This Service Information bulletin supersedes SI B13 04 09 **dated January 2011.**

NEW N54 Engine: Diagnosis of Cold Start Rough Running with Misfire Faults

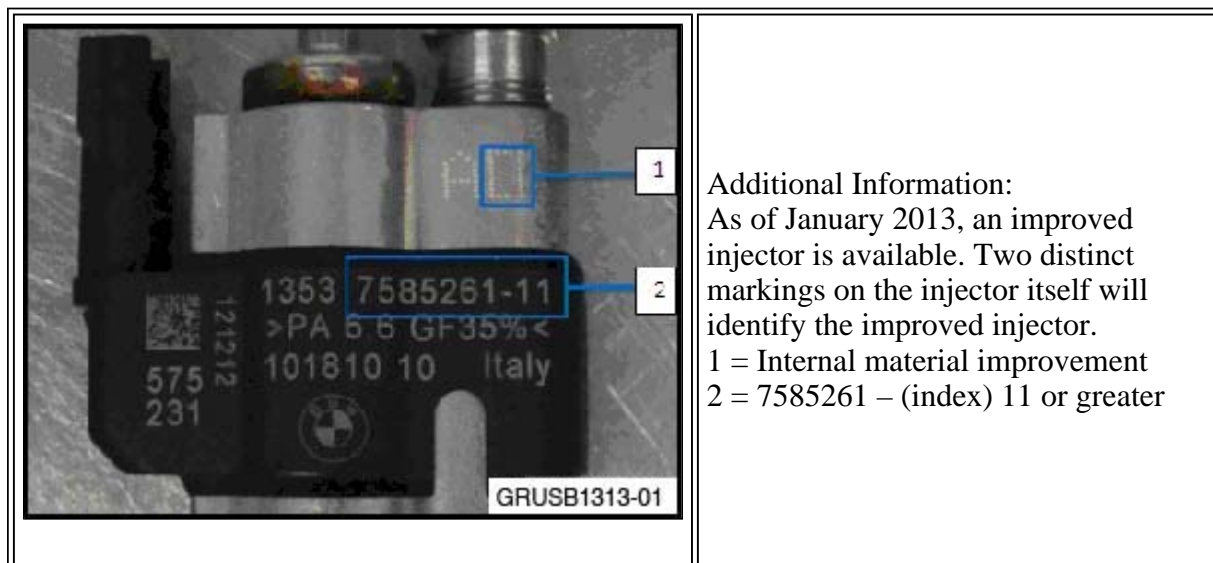
See the photo below to properly identify the index number.

IMPORTANT: Injectors with index 11 and higher have a different calibration than injectors with index 10 and lower. Due to this difference, injectors with index 11 and higher and injectors with index 10 and lower cannot be used in the same engine.

In the case of reproducible “cold start” rough engine running with corresponding misfire faults, replace the high-pressure injectors using improved P/N 13 53 8 616 079 with index 11 or higher. Follow Repair Instruction 13 53 310 for injector removal and installation. Additionally, the spark plugs from the misfiring cylinders which were found to be soaked (“wet”) with fuel should be replaced.
